Diagnostic and Repair Plan

FSC 13-24-5902 Missing HV cable clamps

ISSUE DESCRIPTION:

Cable clamp missing on some BEB Gen3.0 buses for the HV Charge port cables near the curbside HVJBox.

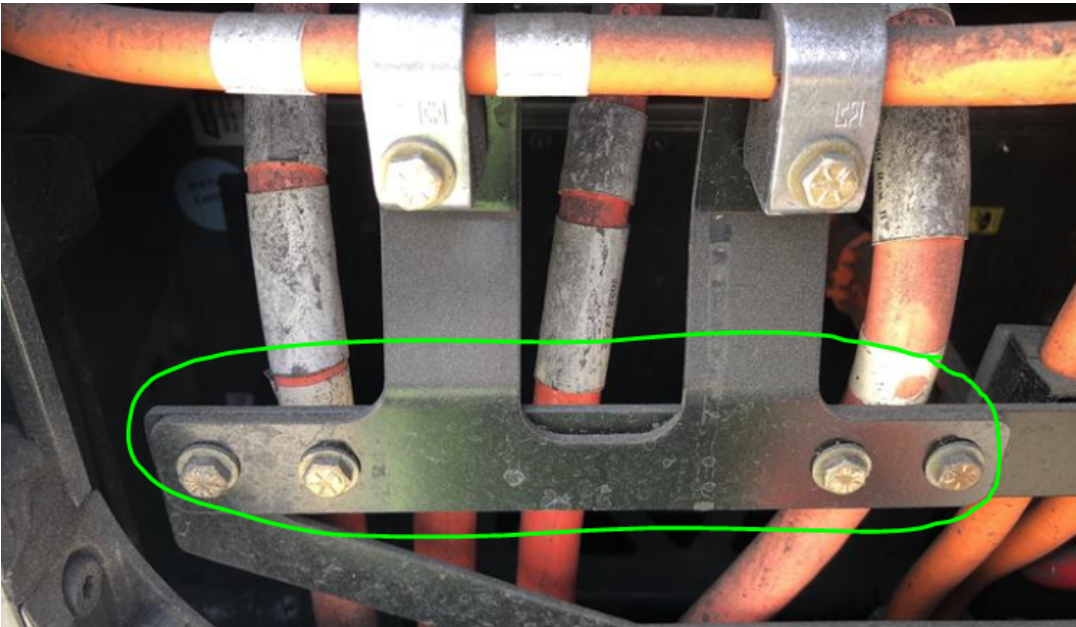
Verify nylon cable clamp is missing by visual inspection - visible through upper rear curbside access door.
